DEVELOPMENT ASSESSMENT REPORT				
Application No.	DA/2021/0480			
Address	2 Loughlin Street ROZELLE NSW 2039			
Proposal	Demolition of existing cottage and construction of new three level residence with parking			
Date of Lodgement	18 June 2021			
Applicant	Mr Ray Stevens			
Owner	Ms Karen J Twitchett Mr Ian C Jones			
Number of Submissions	Initial: 4 After Renotification: 3			
Value of works	\$970,000.00			
Reason for determination at Planning Panel	Clause 4.6 variation exceeds 10%			
Main Issues	Permissibility Streetscape and local character Bulk and scale Visual privacy impacts			
Recommendation	Approval with Conditions			
Attachment A	Recommended conditions of consent			
Attachment B	Plans of proposed development			
Attachment C	Clause 4.6 Exception to Development Standards			
 <p>Figure 1: Locality Map</p>				
Subject Site		Objectors		↑ N
Notified Area		Supporters

This report is an assessment of the application submitted to Council for Demolition of existing cottage and construction of new three level residence with parking at 2 Loughlin Street ROZELLE NSW 2039.

UPPER TERRACE GARDEN PLANTER

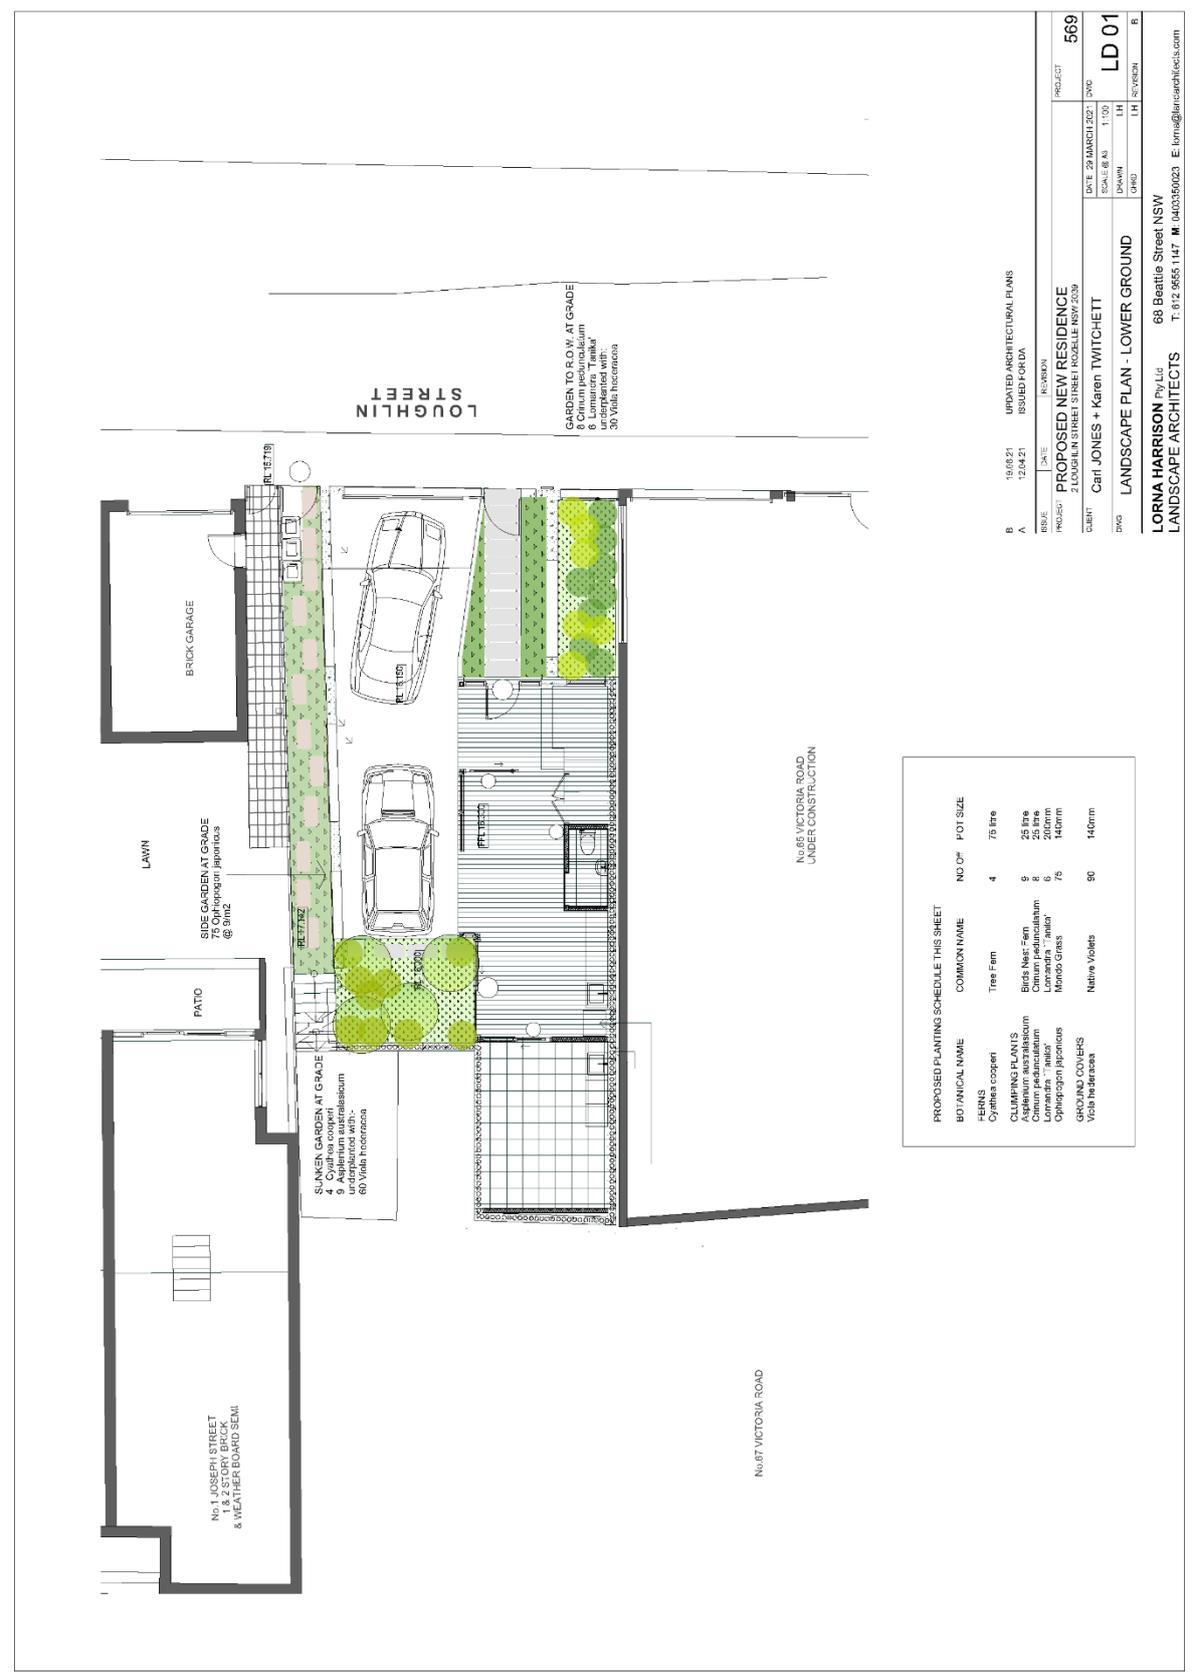
In addition, a planter is proposed along the northern boundary on the first floor. In this regard, it is noted that vegetation cannot be, solely, used for screening. Further, to maintain the planter boxes, e.g., watering, these need to be accessed, which will result in additional adverse privacy impacts to adjoining sites, in particular to No. 1 Joseph Street.

As a result, a condition is recommended, requiring that this planter be deleted from the proposal. To ensure that this area is not used, it is also recommended to delete the balustrade along the proposed planter. Further, it is recommended to impose a condition, requiring a privacy screen along the western and northern edge of the first floor balcony at the front. The length of this screen, along the northern boundary, must ensure that there will be no sightlines within 9 metres and 45 degrees between this balcony and open space at the adjoining sites, No. 1 and No. 3 Joseph Street. Given that this balcony is adjacent to the garage at No. 1 Joseph Street, it is considered that this screening will not result in undue bulk and scale impacts to adjoining sites.

- b. That the planter and balustrade on the first floor along the northern boundary has been deleted.
